Re: Re-subdivision – Nottingham Hills Lots 19 & 21

TITLE OF PLAN:	Conservation Design Development Nottingham Hills Subdivision; 4 lot Re-subdivision of Lots 19 and 21
DATE RECEIVED:	March 2020
DATE DISTRIBUTED:	May 2020
REVIEW DEADLINE:	July 7, 2020

Re: Nottingham Hills Subdivision  
Lots 19 & 21 – Re-Subdivision

**EROSION & SEDIMENT CONTROL NARRATIVE**

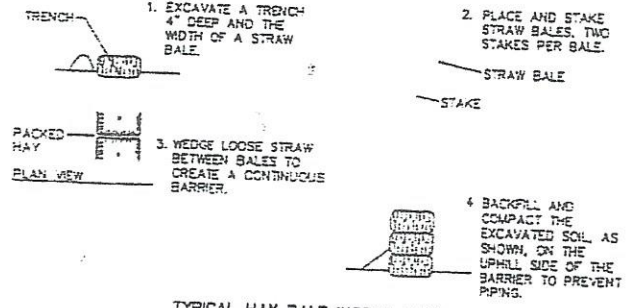
- In addition, in my e-mail correspondence of June 29, 2020, I indicated an Erosion and Sedimentation Control Plan pursuant to Section 5-2-2(G) of the Subdivision Regulations needed to be provided. However, I do not have an Erosion and Sedimentation Control Plan prepared pursuant to Section 4-2-4 of the Subdivision Regulations.

4. Erosion and Sedimentation and Control Plan

See attached Ex. 1 which will be added to a new page (Page 5 of 5) to this applications plans.
